Technical Bulletin

Bulletin Number: 350 Revision Number: R-01

SUBJECT: STICKING SELECT BUTTONS ON LANDSCAPES

MODEL: Coke Landscape Venders beginning serial number 0001-2949DK to 0001-2995BL.

Select Button (Gray)
801,805,59x.x1
Figure 1

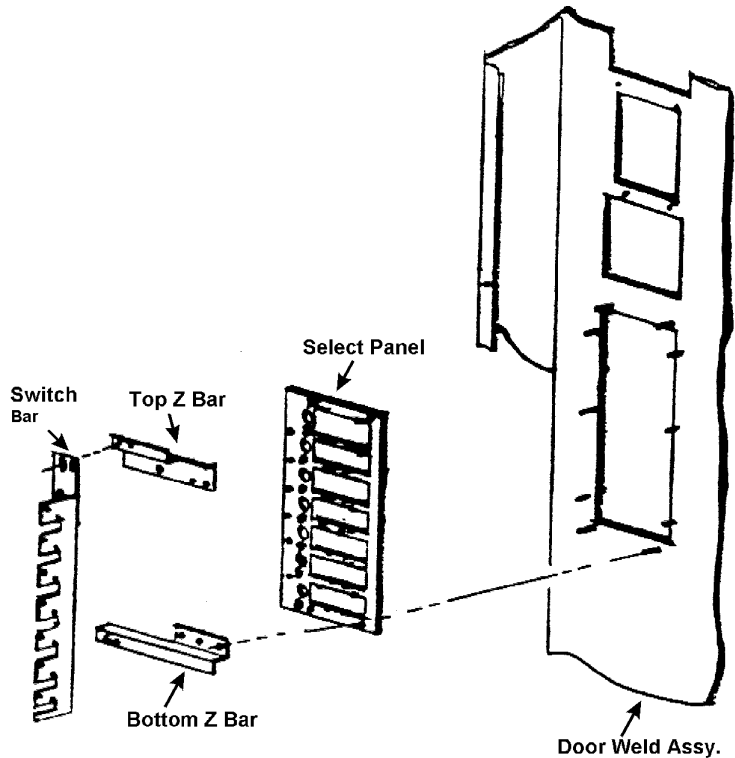
REASON: To provide a correction for sticking select buttons in early Landscape models.

1. Replace the spring in the select button.
2. Replace the top and bottom Z Bars used to secure the switch bar assembly.

1 - 901,700,72x.x1	Spring
1 - 432,050,42x.x3	Z Bar Top
1 - 432,050,43x.x3	Z Bar Bottom
